May 28, 2008

Re: Responses to Comments on the 95% Design  
Herrick Hollow Creek Restoration  
Richardson Hill Landfill Site

**Comments from USEPA, USFWS and NYSDEC  
Contained in USEPA's Letter Dated April 30, 2008**

# STREAM RESTORATION PLAN

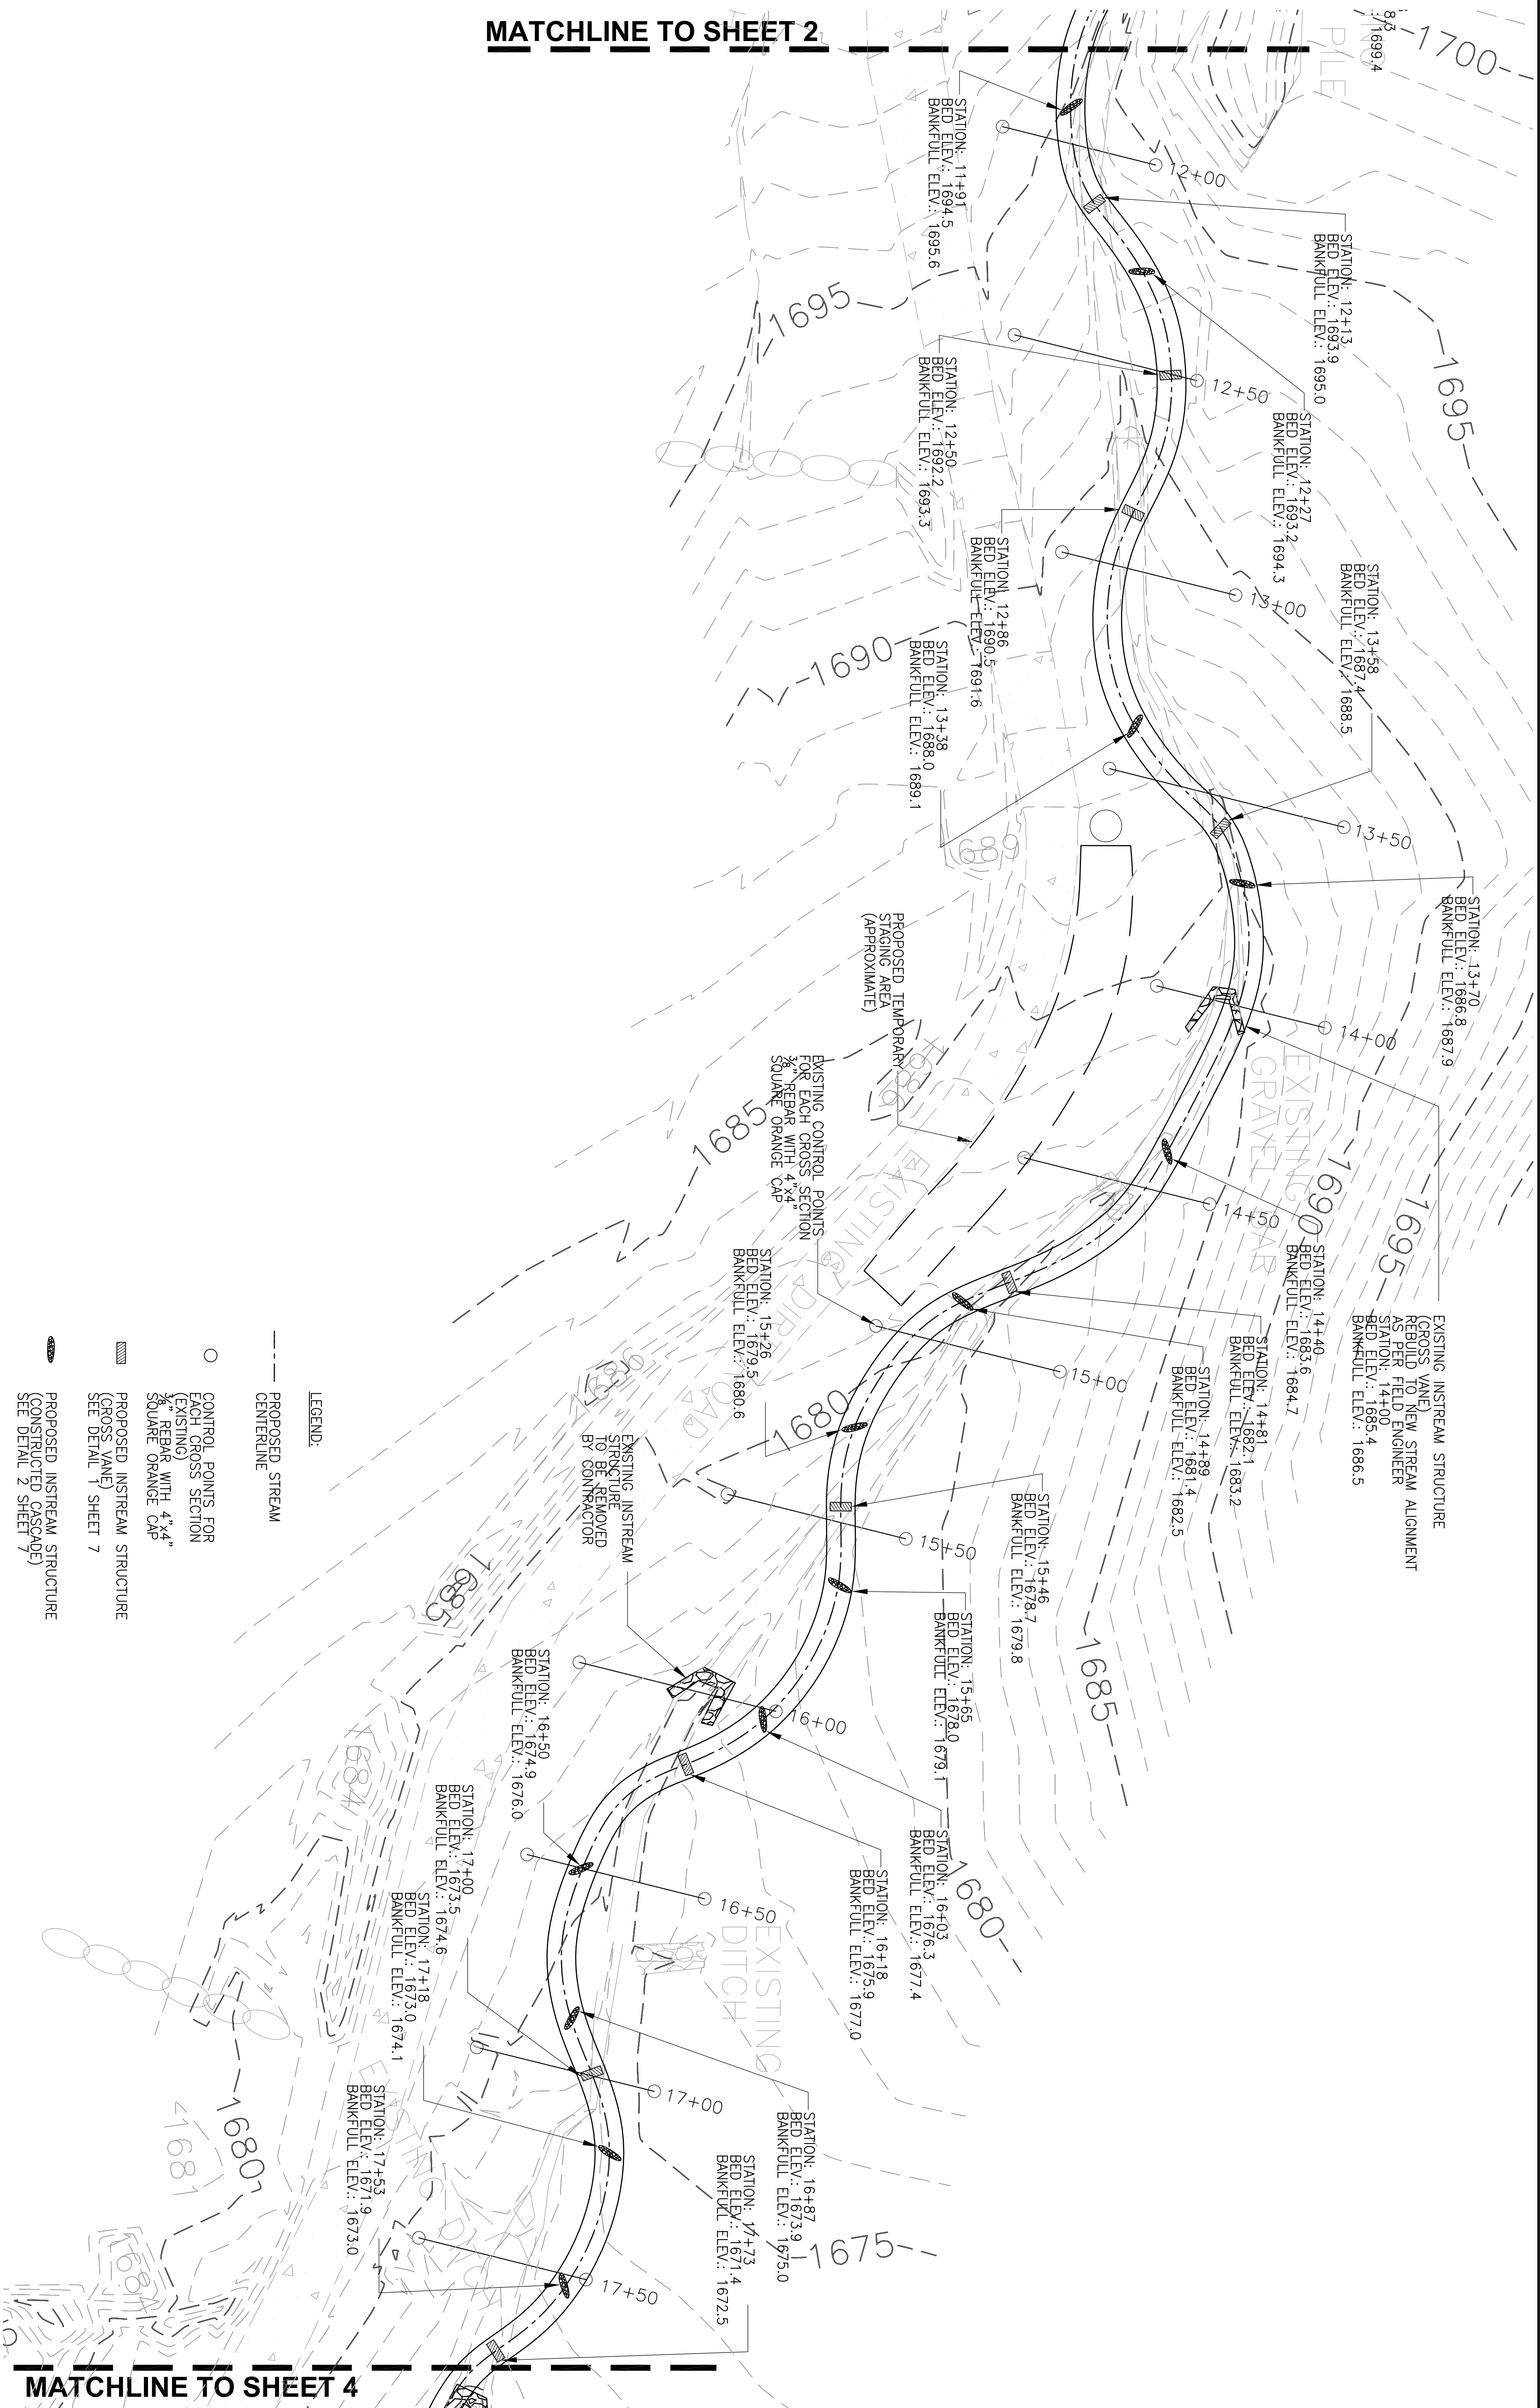
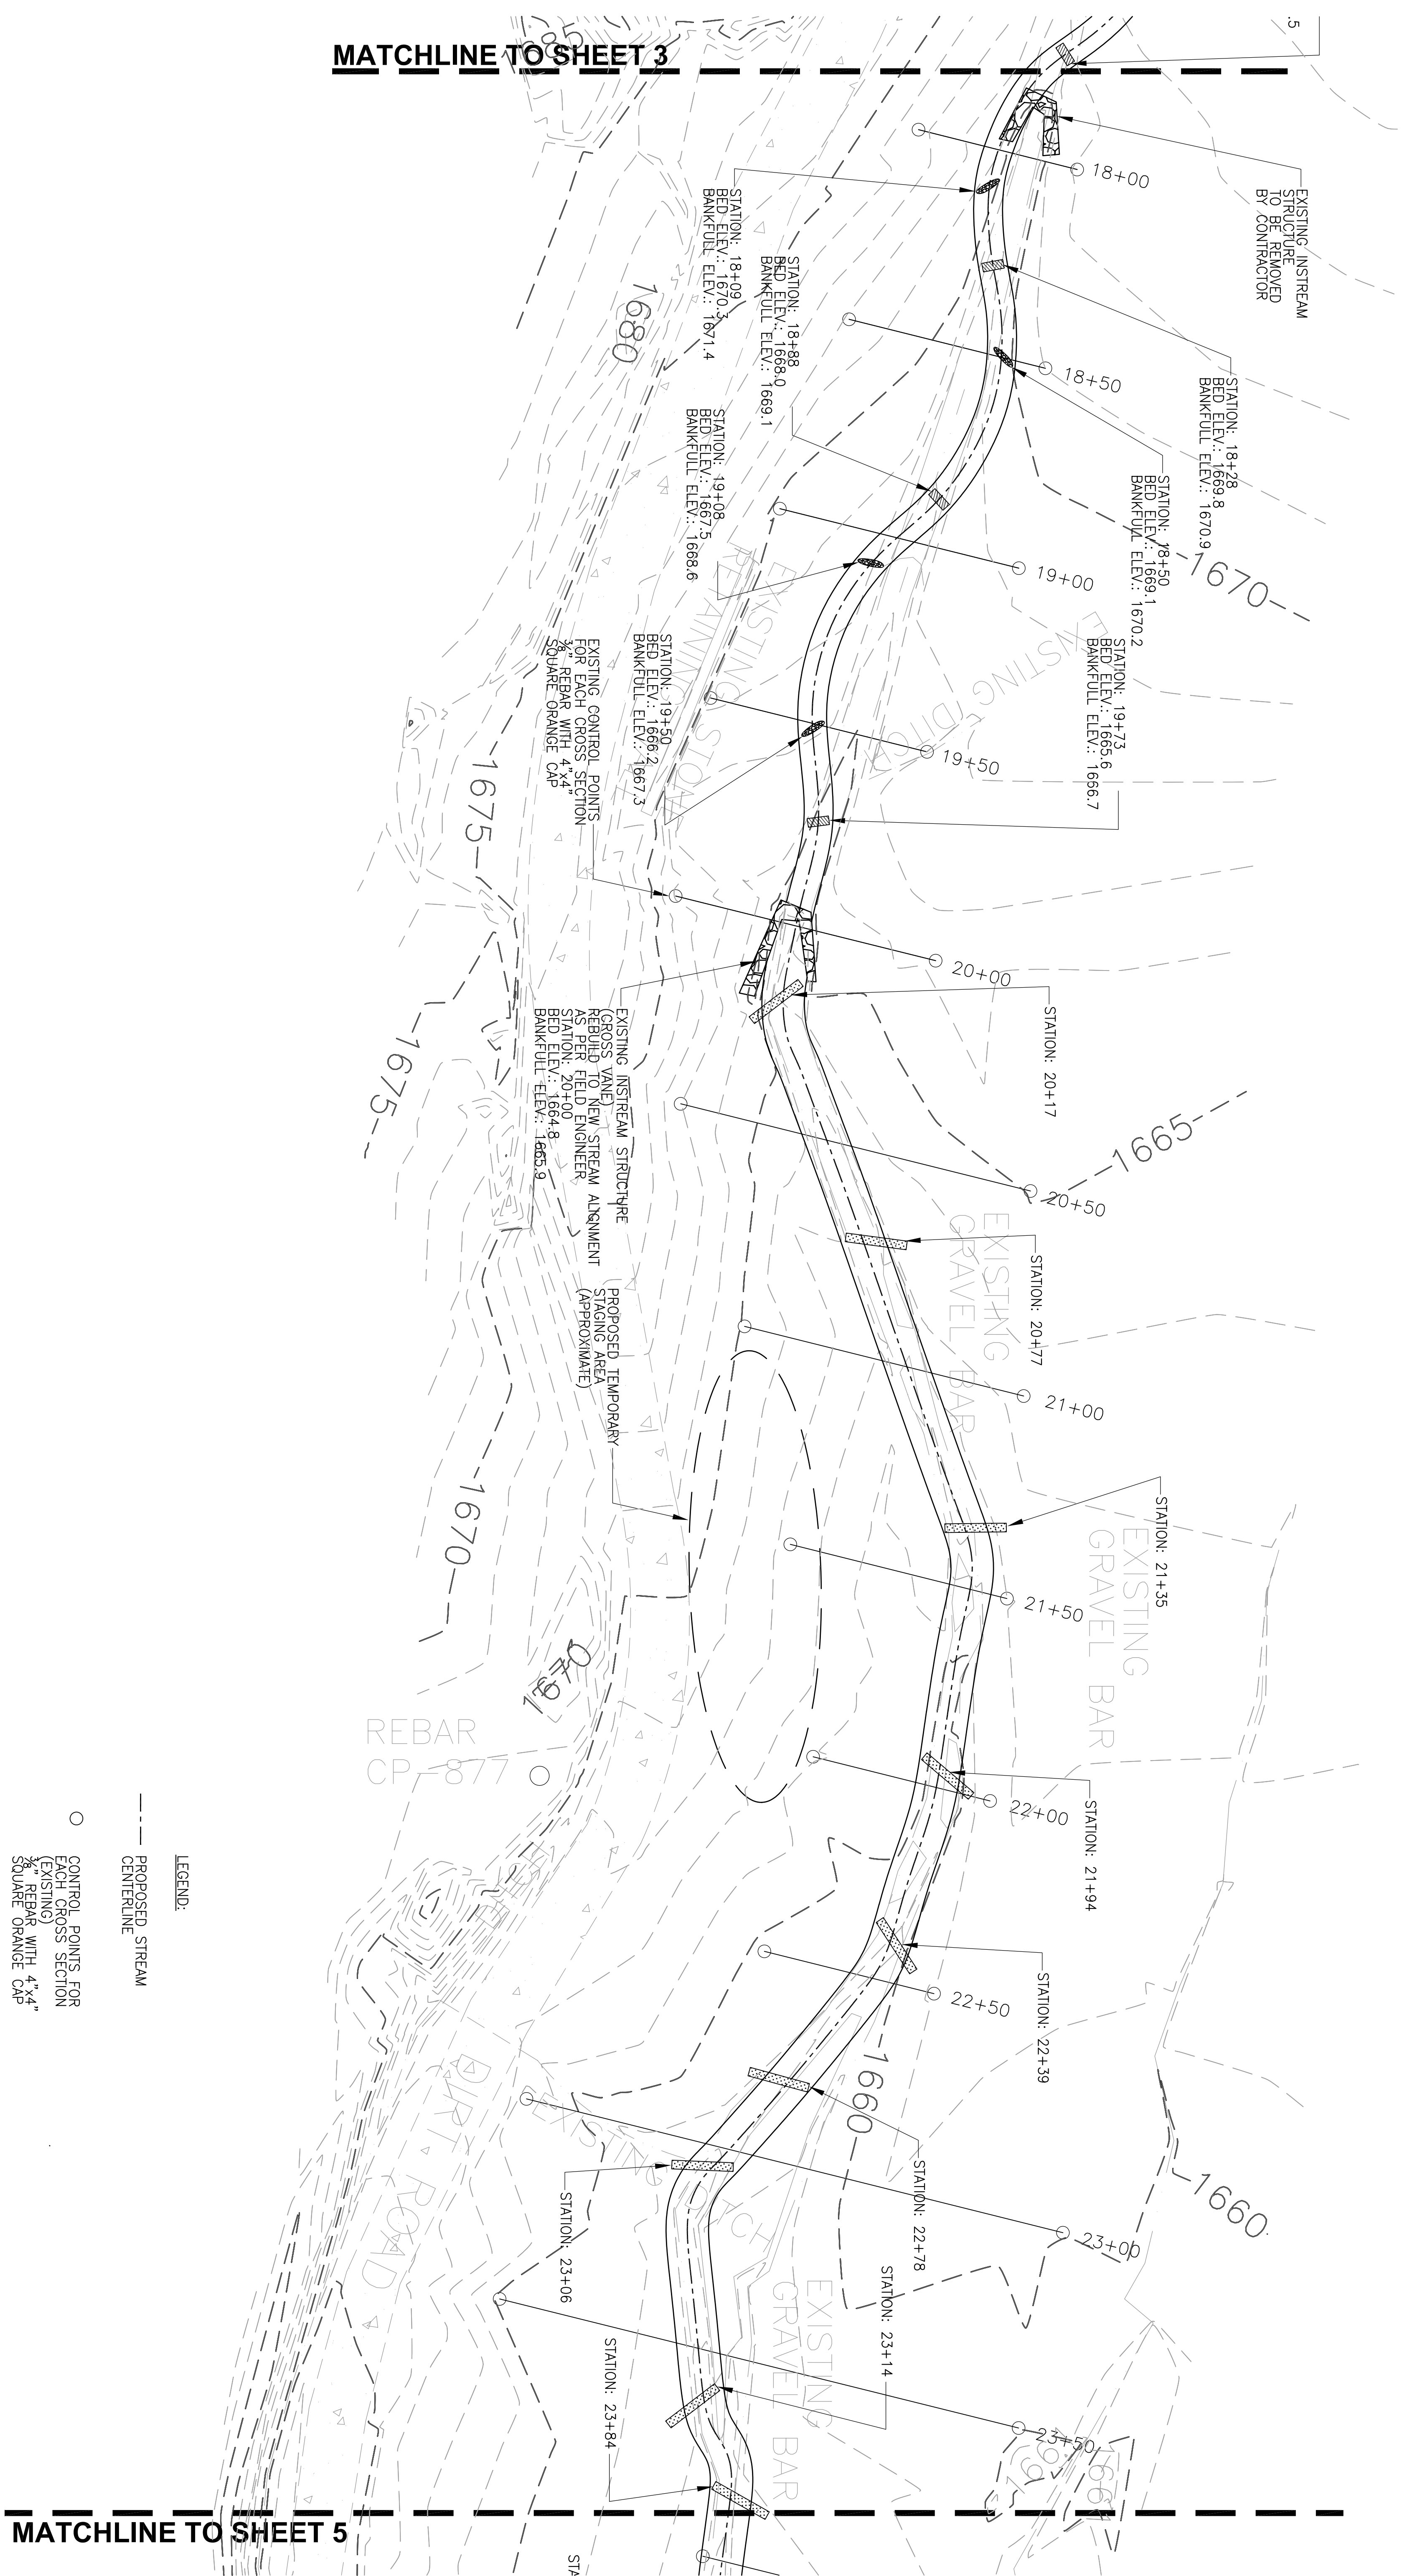
## **Sheets 15-18**

1. If log vanes and cross vanes have the same angle specifications (20-30 degrees from the bank and 4-7 degrees arm angle), and both start from bankfull elevation and end at invert elevation, how can log vanes span the entire channel while rock vane arms span 1/3 of bankfull channel? This needs careful consideration, particularly since designs show the entire lower channel from approximately 20+00 to 32+00 to contain only log vane structures. Please address design concern outlined.

2. Please justify the choice of log vane structures in this area vs. cross vanes or cascades. As noted in Specifications SR-12, these structures are designed to reduce shear stress on the banks. If the lowest point of the structure is at the tie-in to the bank, that location will be the thalweg and as such will be the point of greatest shear stress. These structures should therefore be redesigned to meet the invert away from the bank as for rock or cross vanes, or other structures should be used that better meet stated design goals.

3. Additional vegetative materials should be placed at banks upstream and downstream from log vane tie-in to prevent flanking.

*Response* – Item 2 below has been noted, and edits will be made to reflect that log vanes will be keyed into the streambed invert in the center of the channel (1/2 channel width). This change is relevant to the following response, which addresses Item #1

Manipulation of log vane and cross vane arm orientation within acceptable ranges (20-30 degrees from the bank and 4-7 degrees arm angle) allows for both log vanes and cross vanes to be installed in the manner prescribed. This is due to the narrow nature of the channel. Specifically, because the design channel width in Segment III (where log vanes are prescribed) is 10.6 feet, the difference between 1/3 channel width (3.5 feet) and 1/2 channel width (5.3 feet) is only 1.8 feet. Adhering to the range of allowable log vane orientation (20-30 degrees from bank and 4% to 7% arm slope angle) allows for the extension of the upstream invert of the log vane so that it can span 1/2 of the channel width (at 30 degree angle from bank and 4% arm angle, for instance), while a cross vane arm can adhere to the same acceptable range of orientation and span only 1/3 channel width (at something closer to 30° from bank and a 7% arm angle, for instance).

*Response* – Plans, details, and specifications (Construction Specification SR-12: Log Vane) have been edited to reflect the following change:

The upstream terminus of the log vanes will be located at mid-channel. The log vane shall be keyed into the streambed at the desired bed elevation so that the log vane spans 1/2 channel width. The log vane will only tie into the downstream outer bank (at the bankfull elevation) and into the upstream streambed invert at 1/2

the channel width. This will maintain the thalweg in the center, or just off center, of the channel.

The use of log vanes in Segment III was selected over other methods, such as cascades or cross vanes, because they are the least inhibitive method to fish passage, identified in the Goals and Objectives Memorandum as a primary consideration in the restoration design of the lower third (Segment III) of the stream reach to be reconstructed. Log vanes also provide a component of large woody debris (LWD) in the channel, identified in the Basis of Design Report as a significant physical component affecting form and function of the reference reaches. Addition of LWD in the lower third of the channel augments instream habitat.

*Response* – Substantial streambank treatments, including coir logs, coir mats, live stakes, and erosion control fabric are prescribed as bank treatments throughout the course of the restored channel. It is envisioned that, commensurate with the prescribed amending of streamside soils, a great deal of colonization from adjacent intact vegetation will occur. Even in the existing poor soil conditions we have seen rapid and extensive colonization of the riparian area by herbaceous and woody species since the last significant disturbance of the near channel area occurred in September '06.
